**PIPER LANE PUD (PDT 16-2 and ARA 16-1)**

## TENTATIVE PLANNED UNIT DEVELOPMENT STAFF REPORT

Piper Lane PUD (PDT 16-2, ARA 16-1)

- Attachment A: Vicinity map
- Attachment B: Applicant's Site Plans (Reduced)
- Attachment C: Applicant's Narrative and Informational Items
- Attachment D: Public Testimony

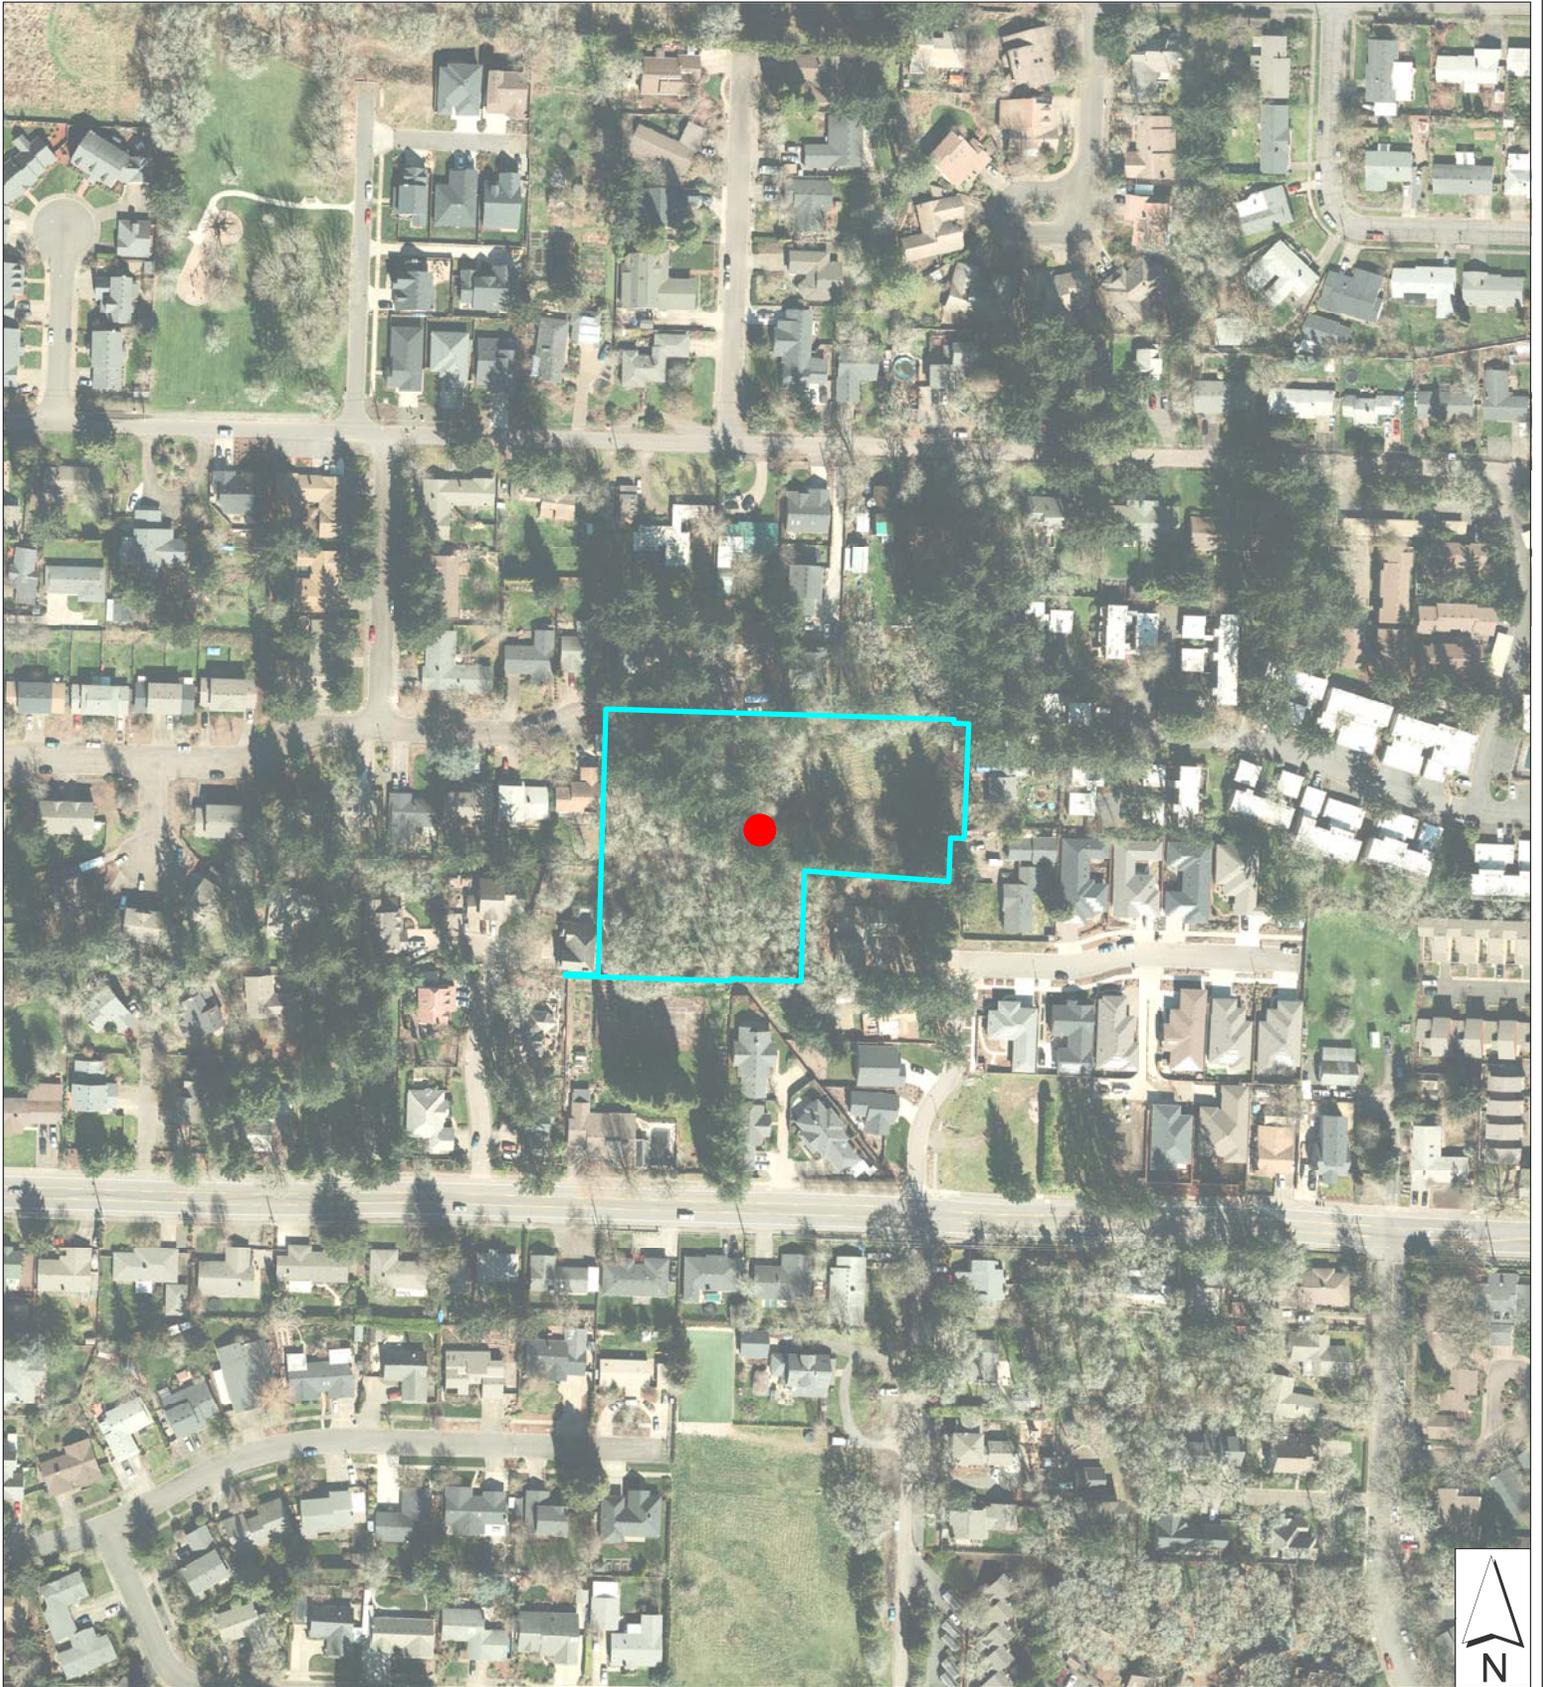
Regarding subsection (2)(d), the proposed development of a secondary emergency access through the existing 25 foot wide Piper Lane right-of-way adjacent to 17-03-19-13 TL 2401 (aka 1420 Piper Lane), see Sheet L2.0 – Site Plan, demonstrates compliance with this standard.

As shown on Note 11 on the applicant's Topographic Survey, there is a 25-foot wide Emergency Access, Pedestrian and Bicycle Way (aka Public Accessway) with a 25-foot nominal width that is adjacent to TL 2401 and is identified on Sheet L2.0 – Site Plan as a 25-foot wide right-of-way. As depicted on Sheet L2.0, the applicant proposes the construction of a 14-foot roadway for Emergency Secondary Access that is capable of accommodating 80,000 lb. Gross Vehicle Weight. Additionally, it is noted that the emergency access will be constructed through the PEPI process in accordance with City standards and will also accommodate bicycles and pedestrians.

This standard applies per EC 9.6795(2)(c), for the proposed solid waste storage areas that is identified on Sheet L2.0 – Site Plan as a covered trash enclosure. At the time of the building permit, the facility will be required to be covered, hydraulically isolated and connected to the private wastewater system.

A feature explicitly included in the application that triggers review of other development standards are the parking courts which requires compliance with EC 9.6420 Parking Area Standards. Based on the dimensions shown on Sheet L2.0 for the two parking courts, Public Works staff confirms that the stall and aisle dimensions comply with the parking area standards at EC 9.6420(1). Additionally the proposed parking lot complies with the parking lot drainage requirements at EC 9.6420(2). Land Use staff referral comments otherwise indicate that all applicable development standards are met (e.g. multi-family standards at EC 9.5500) except as addressed in the Adjustment Review evaluation provided below.

- The Final PUD plans shall be modified so that the Piper Lane paved section is reduced to a 14-foot width, beginning at the end of the proposed curb and gutter near the northeast corner of the development site and proceeding in a southerly direction towards the northwest corner of TL 800. The plans shall also note the construction of a barrier which will prevent motorists from gaining access to the private roadway easement. The plans shall also be modified to indicate that the 14-foot paved section is for Fire, Bicycle and Pedestrian purposes only and the proposed vehicle turnaround adjacent to Building G shall

be removed from the plans.
